City of Palo Alto

City Council Staff Report

Summary Title: PUBLIC HEARING: 670 Los Trancos

Title: PUBLIC HEARING: 670 Los Trancos Road [16PLN-00266]: Site and Design Review to Allow the Construction of a new Single Family House and Guest House With a Total of approximately 10,960 Square Feet of Floor Area. Environmental Assessment: Categorically Exempt From CEQA Pursuant to Guidelines Section 15303 (New Construction or Conversion of Small Structures). Zoning District: OS

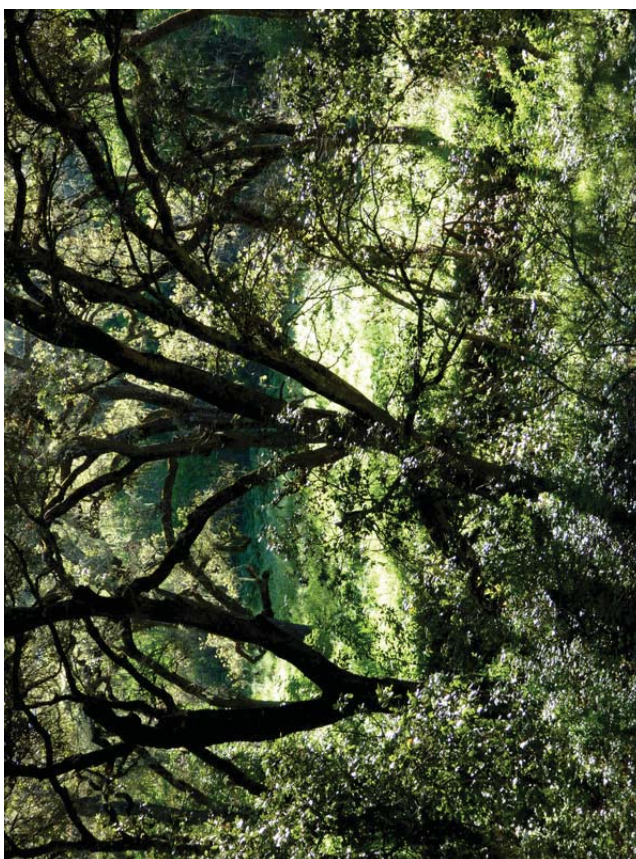
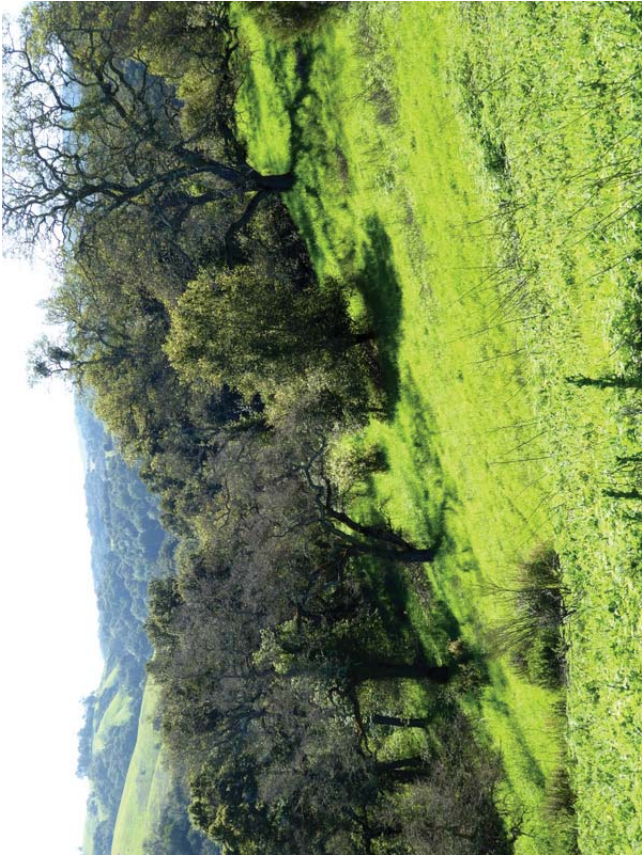
to come face-to-face at the top of a hill with a building, when today there are only sky views and natural green hills to look at.

There is something uniquely beautiful about the open space park at Arastradero, which borders our equally beautiful Foothills Park, that the city had the foresight to create and protect decades ago. Arastradero is home to a wide variety of animals in a relatively small space, with a wildlife density not easily seen elsewhere. Additionally, sunlight reflects through the tree branches of this park, radiating off the hillsides, in a way similar to that of Yosemite Valley (see photos). This is not ordinary open space of mere grass and trees. It is special and should be protected.

The City Council is called upon to please respect the wisely crafted building codes of Palo Alto, that were designed to protect the well-being of the citizenry, with vision for our future and our children, and to uphold what is right for the good of the public. This park cannot be a private playground for a lucky few. It would be very wrong to allow a building on this hilltop. Any development on this parcel should be kept completely out of sight of the park and its trails.
